UNITED STATES
NUCLEAR REGULATORY COMMISSION

SUBJECT: NRC INSPECTION REPORT NO. 70-143/2006-006

SUBJECT: SPECIAL INSPECTION TEAM CHARTER FOR NUCLEAR FUEL
SERVICES (NFS) - DOCKET NO. 70-143 (INSPECTION REPORT
NUMBER 70-143/2006-006)

Nuclear Fuel Services, Inc.
NRC Inspection Report 70-143/2006-006

Figure 1: Event time line showing three previous occasions where either a small amount yellow solution or evidence of yellow solution was found in the bag filter enclosure (ENCLOS-2M05).

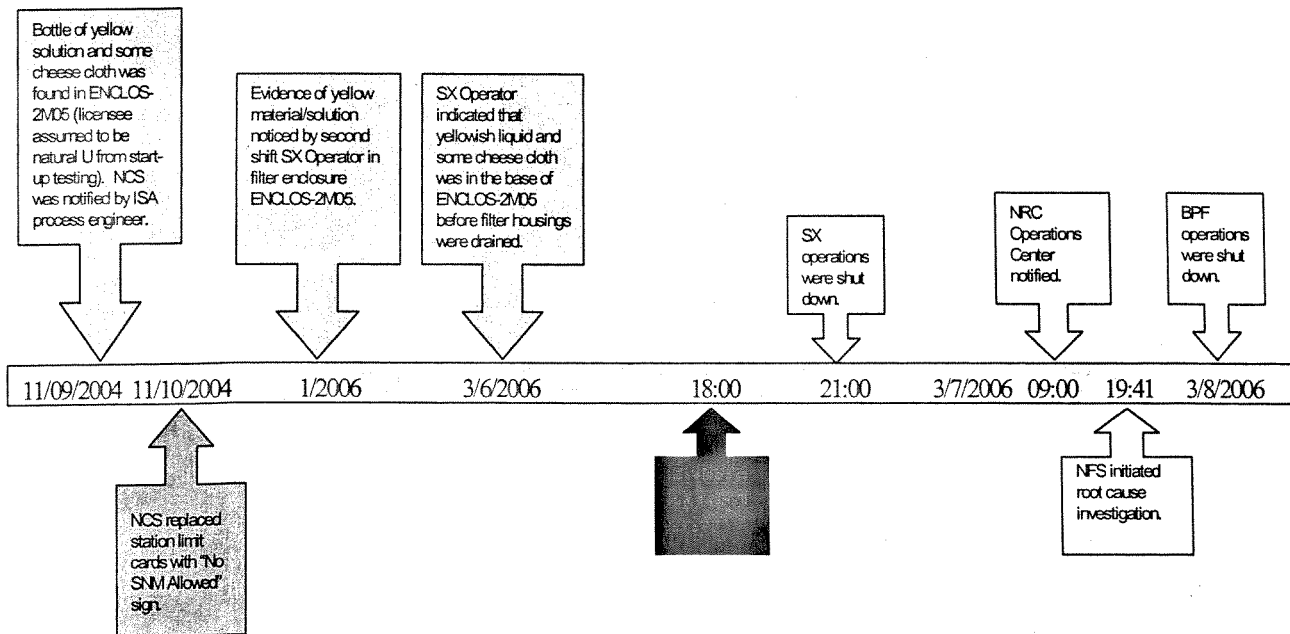
The inspectors noted that there were three previous occasions where either a small amount of yellow solution or evidence of yellow solution was found in the enclosure (see Figure 1). The operators involved reported their observations to their supervisor. The personnel involved thought the material was depleted uranium solution from start-up testing. None of the observed events were reported in the licensee's problem identification, resolution, and correction system (PIRCS).

The inspectors identified three examples, prior to the event, where yellow solution was found in the 2M05 enclosure. Since the enclosure was not approved for use, the presence of yellow solution, possibly uranyl nitrate, was not authorized. In two cases, area supervision was notified, but the issue was not entered into the PIRCS system for formal safety review and was not reported to the Nuclear Criticality Safety function as required by NFS-HS-CL-26. As such, the inspectors concluded that the less-than-rigorous followup to the discovery of yellow solution in three different instances represented lost opportunities to possibly identify and correct the problem before the March 6 spill. The failure to report the events concerning the yellow solution in the 2M05 enclosure in accordance with the requirements of Section 5.1 of NFS-GH-65 is identified as an apparent violation (APV 70-143/2006-006-08).

Figure 2: BPF Tray Dissolver 2M05 Enclosure, Piping and Drains

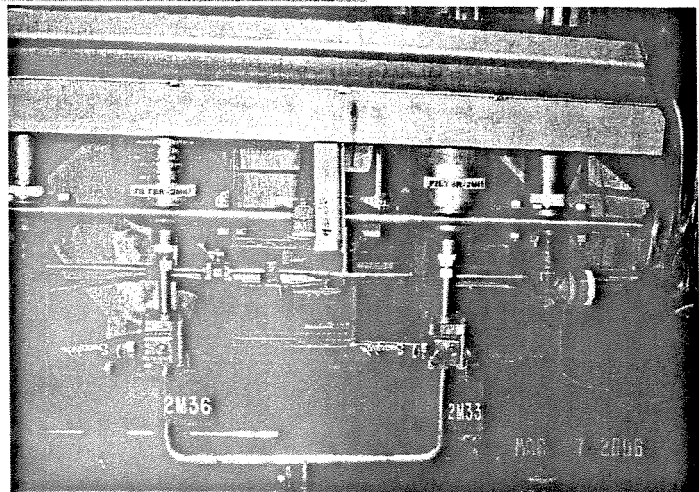
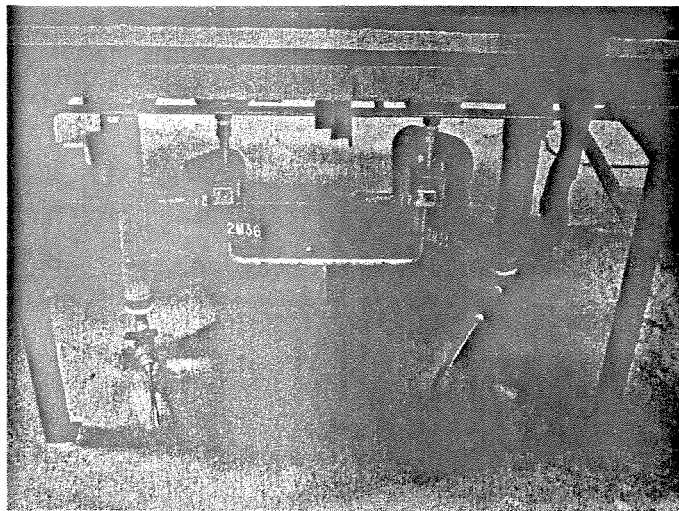
The solvent extraction room was designed with a tray dissolver system which is shown in Figure 2. The tray dissolver system was intended to facilitate recovery of fissile solution from cleanup rags and mop heads and allow spilled solution to be fed directly to solvent extraction. The tray dissolver system had a filter enclosure with two bag filters and a cartridge filter, and the resulting filtrate was designed to be pumped to solvent extraction feed by a direct connection to the solvent extraction feed transfer line. Figure 3 shows the general equipment arrangement for the tray dissolver system and also shows the transfer line connections involved in the spill event. Figure 4 shows the spill, spill flow path, operator locations, and location of the elevator pit.

The tray dissolver filter enclosure had two engineered NCS controls consisting of two drains which each had a diameter of two inches. There were no management measures in place to ensure that the drains could adequately perform their safety function. Items such as cheesecloth and poly-bottles which could block the drains were observed in the enclosure prior to the event (see Figure 1). The filter enclosure was considered out of service, and there were no approved procedures for enclosure operations including maintenance operations. No station limit card was in place, and operators were not trained on the unit. The licensee intended to use the enclosure drains as IROFS, and the drains would have been procedurally checked for obstructions prior to each use of the equipment. Other management measures on the drains would have included installation checks and preventive maintenance which were also not performed. The inspectors determined that the filter enclosure was uncontrolled for the accident sequence of a spill into the enclosure because these controls and measures were not implemented. In addition, a spill contained in the enclosure would not be easily noticed such that multiple spills to the enclosure could result in accumulation of fissile solution if the drains were blocked.

The licensee had performed an NCS analysis for the tray dissolver equipment and had prepared an operating procedure. The inspectors observed that the completed and approved NCS analysis for the tray dissolver process had reviewed the potential for accumulation of fissile solution in the enclosure and established appropriate NCS controls for that accident sequence which consisted of two 2-inch drains which were intended to be designated as IROFS. Because the system was considered out of service, the drains required by the analysis were not completely implemented, and double contingency was not established for the accident sequence of fissile solution spill into the tray dissolver filter enclosure. Specifically, verification of proper installation of the drains was not completed. License application Section 4.1.1.1.3 states, in part, that engineered controls must be verified as being properly installed prior to first use with fissile material. Failure to verify proper installation of the tray dissolver filter enclosure drains prior to use of the system with fissile material is identified as an apparent violation (APV 70-143/2006-006-02).

The inspectors noted that the tray dissolver filter enclosure was installed without isolation valves and was connected to fissile process lines, utilities, and ventilation as if the tray dissolver system was in service and would therefore be required to meet the performance requirement of 10 CFR 70.61(d) for accident sequences leading to criticality due to handling fissile material with the tray dissolver equipment. The inspectors determined that because management measures were not implemented for the enclosure drain system, the enclosure did not meet performance requirements for criticality safety relative to accumulation of fissile material in the enclosure or on the floor of the solvent extraction room. Failure to meet the performance requirements of 10 CFR 70.61(d) for accident sequences related to handling fissile material in the tray dissolver system is identified as an apparent violation **(APV 70-143/2006-006-03)**. The inspectors reviewed similar filter enclosures in the plant and observed that they had isolation valves on both sides and an uninterrupted transfer line to the discharge point. No generic issue was identified relative to similar enclosures and equipment in the facility.
